The Town of Hilton Head Island Regular Design Review Board Meeting

AGENDA

The Town of Hilton Head Island
DESIGN REVIEW BOARD
Minutes of the Tuesday, March 22, 2011 Meeting
1:15pm – Benjamin M. Racusin Council Chambers

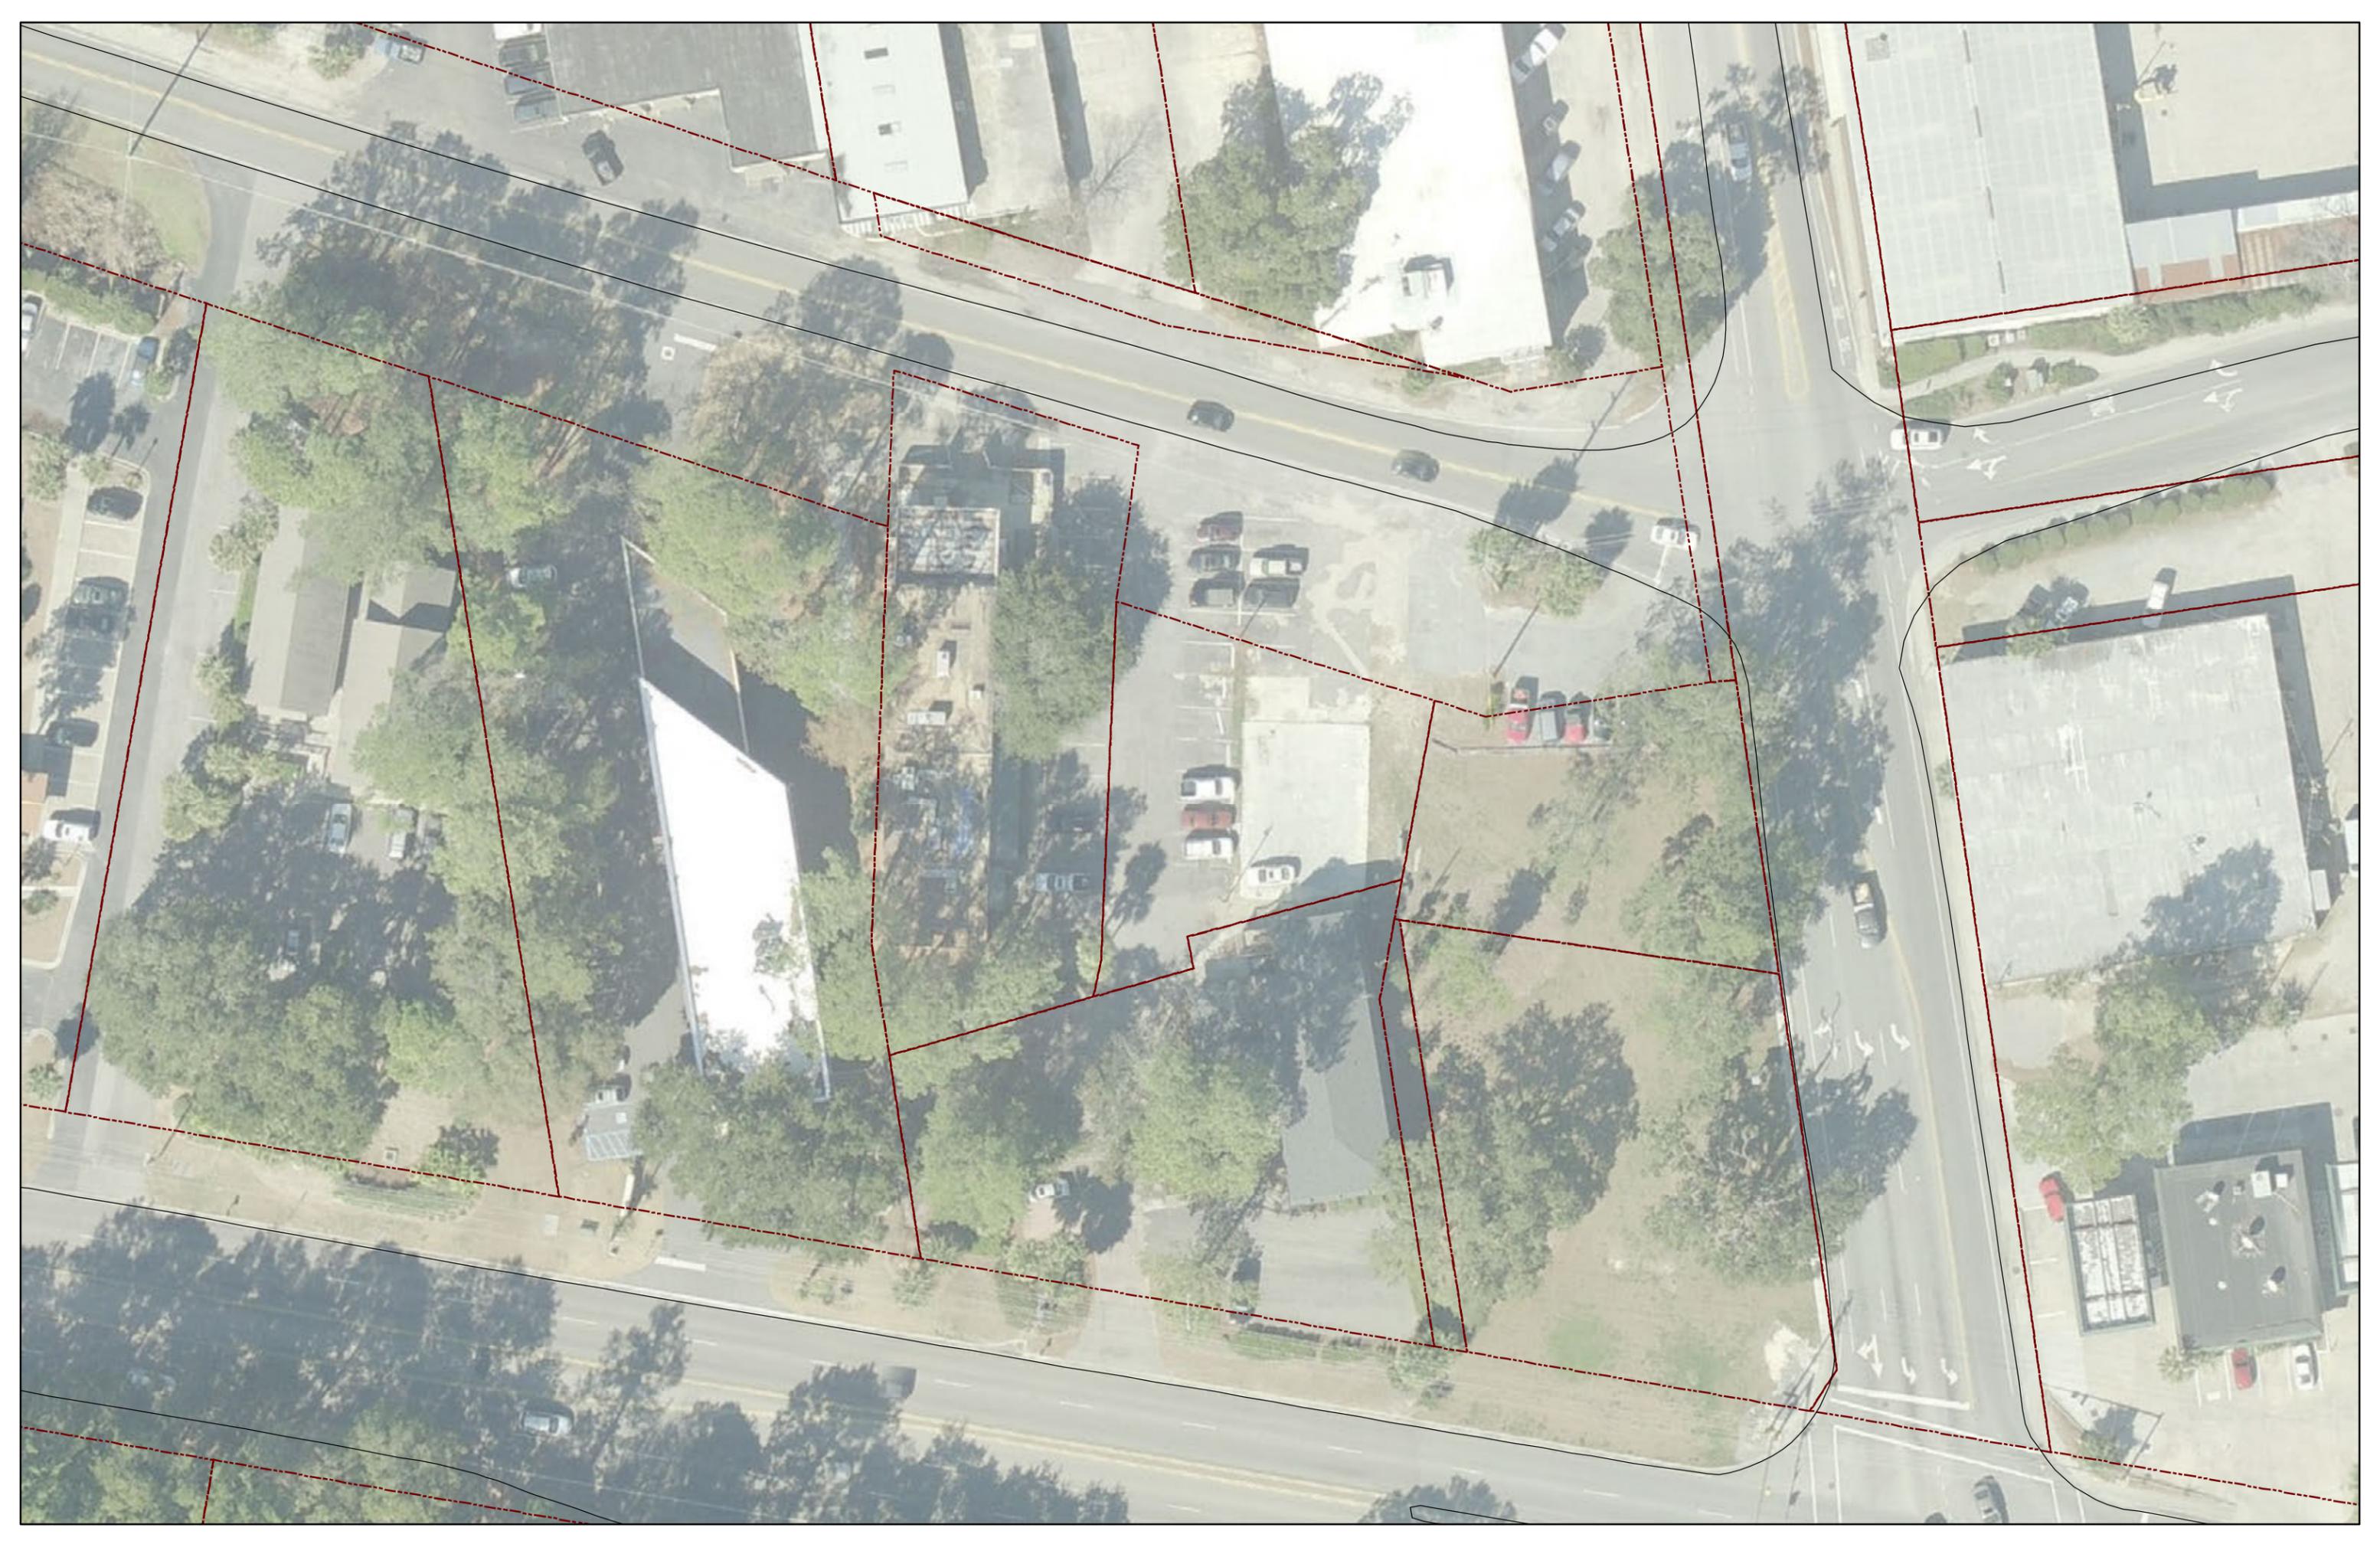
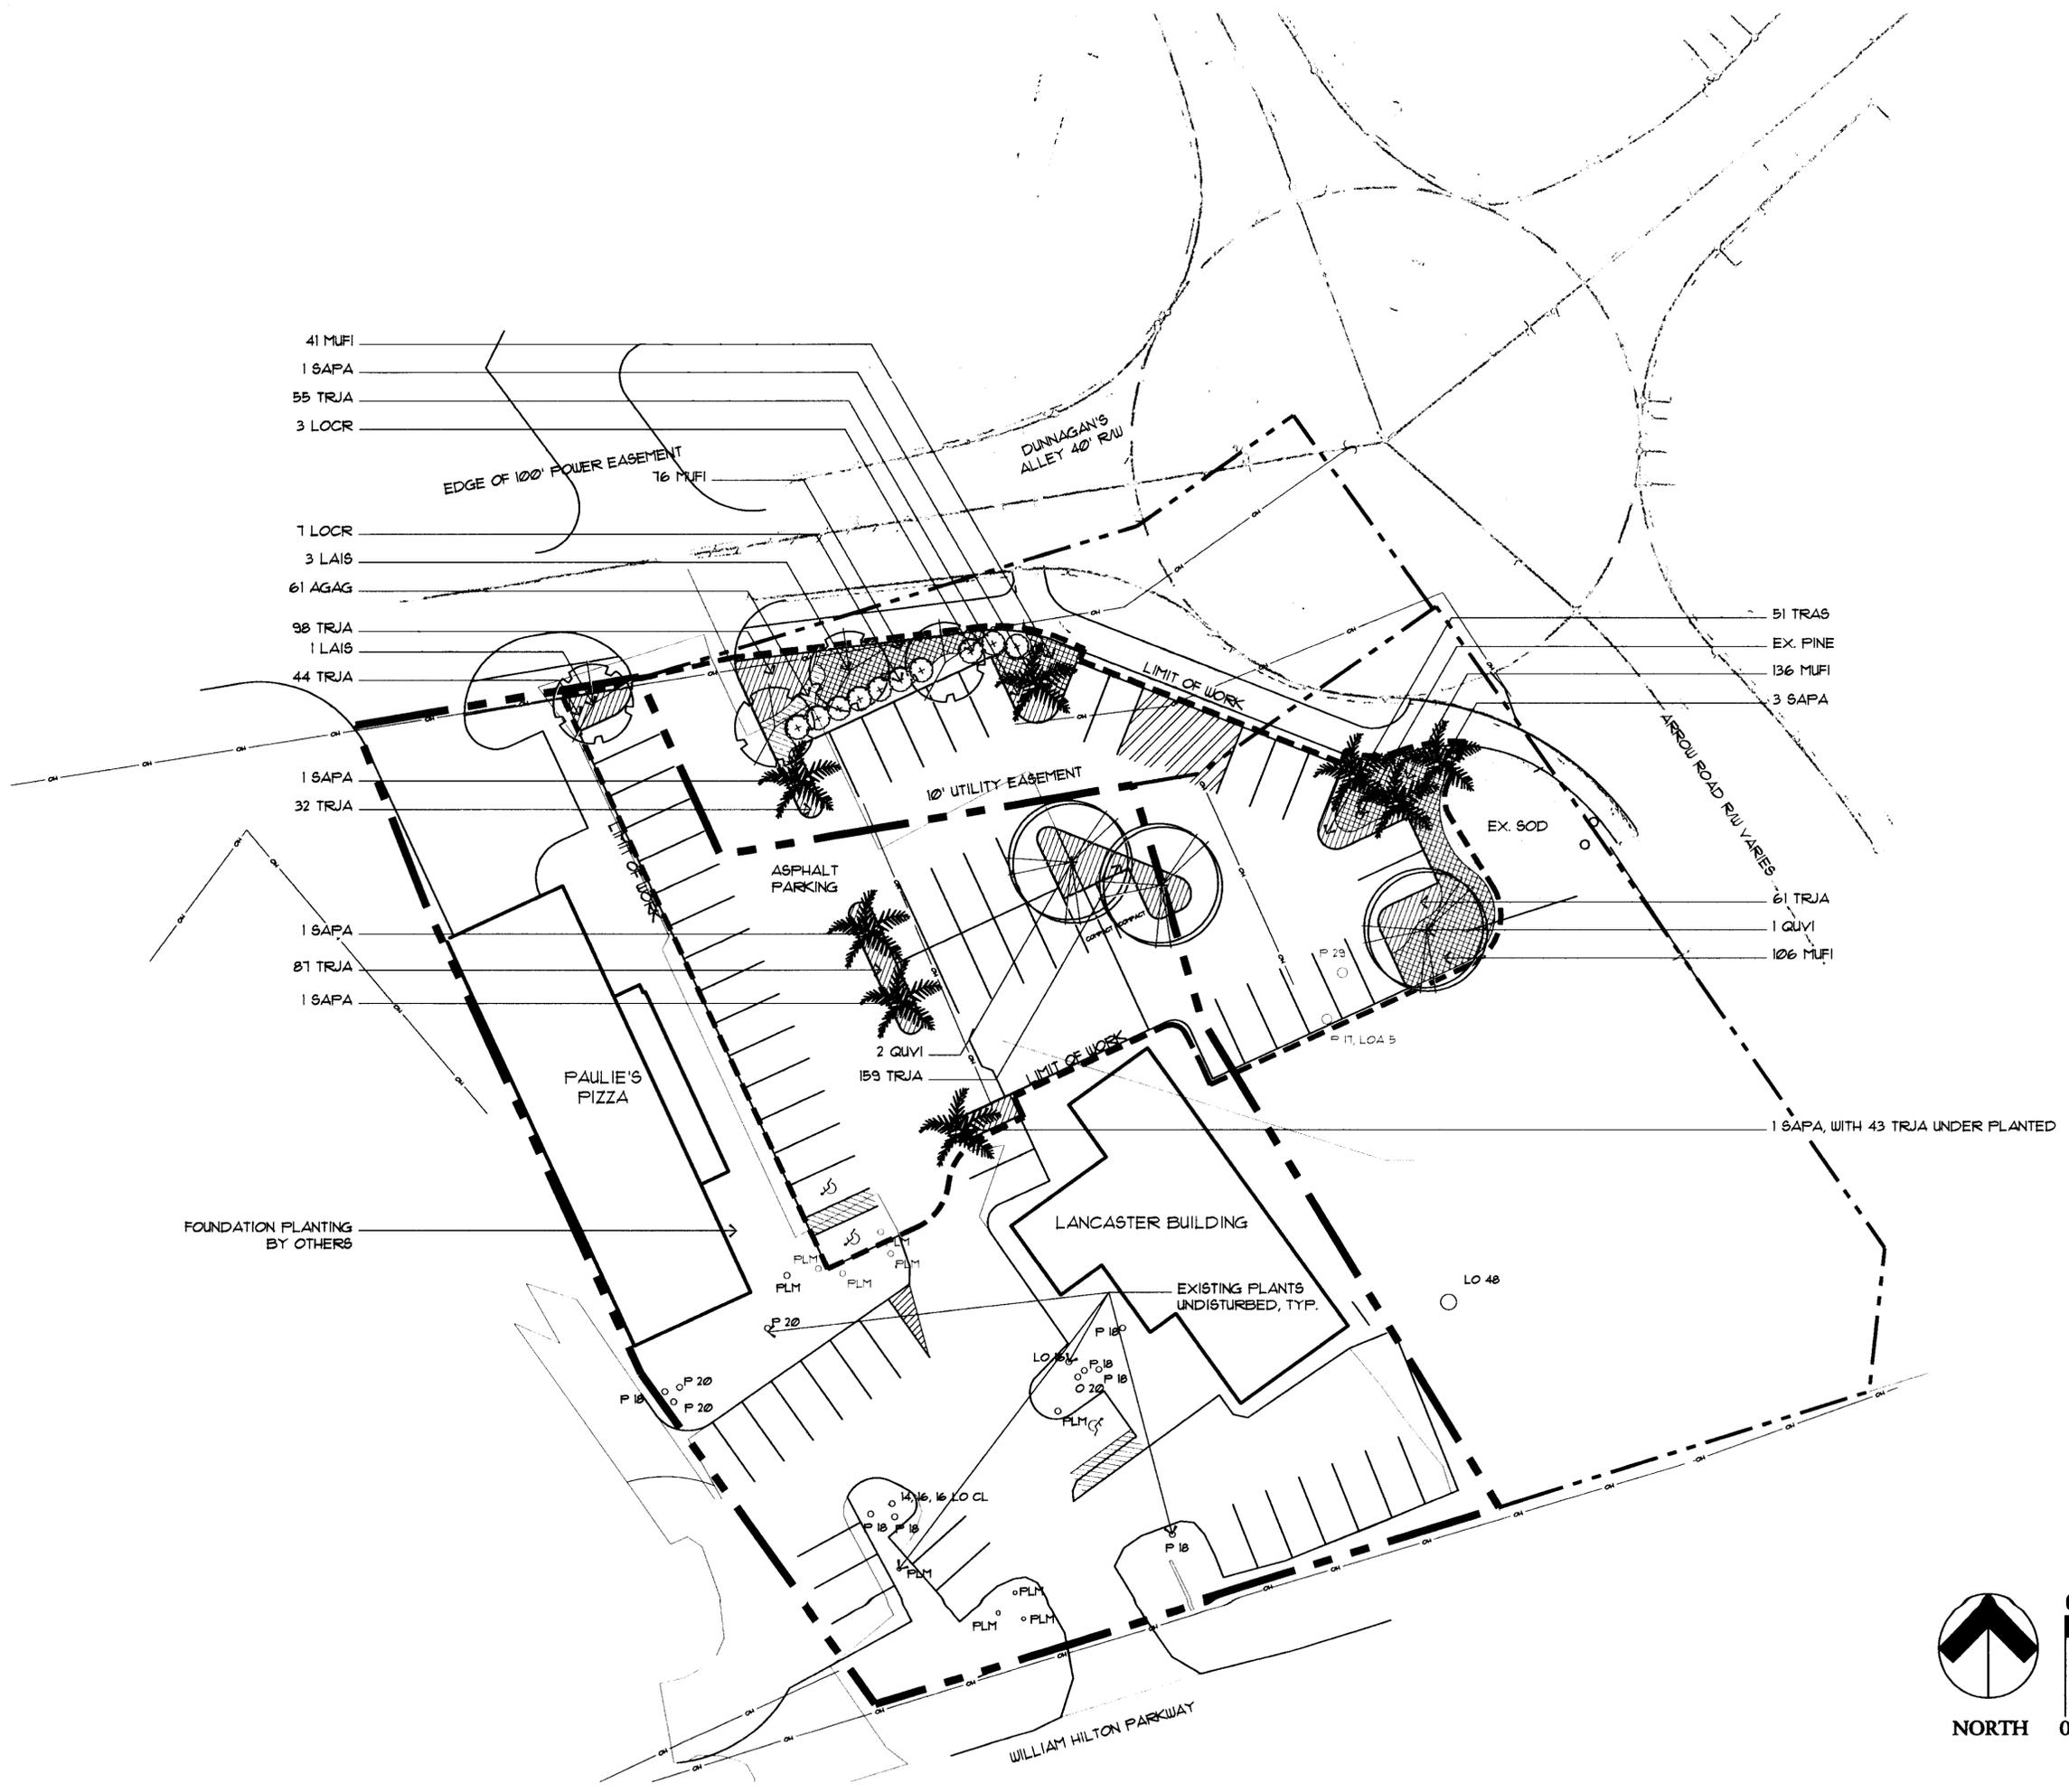
ARCHITECTURAL DESIGN		
Scale, detailing, and geometry are more in keeping with what would seem to be the original design intent. Bay on the left side of the elevation has been abandoned. If landscaping in place is removed or disturbed, it should be replaced with an evergreen material, in kind.		
DESIGN GUIDE/LMO CRITERIA	COMPLIES YES/NO/N/A	COMMENTS OR CONDITIONS
Structure is designed to be appropriate to the neighborhood		
Promotes pedestrian scale and circulation		
Design is unobtrusive and set into the natural environment		
Utilizes natural materials and colors		
Avoids distinctive vernacular styles		
Design is appropriate for its use		
All facades are have equal design characteristics		
Avoids monotonous planes or unrelieved repetition		
Has a strong roof form with enough variety to provide visual interest		
Minimum roof pitch of 6/12		
Overhangs are sufficient for the façade height.		
Forms an details are sufficient to reduce the mass of the structure
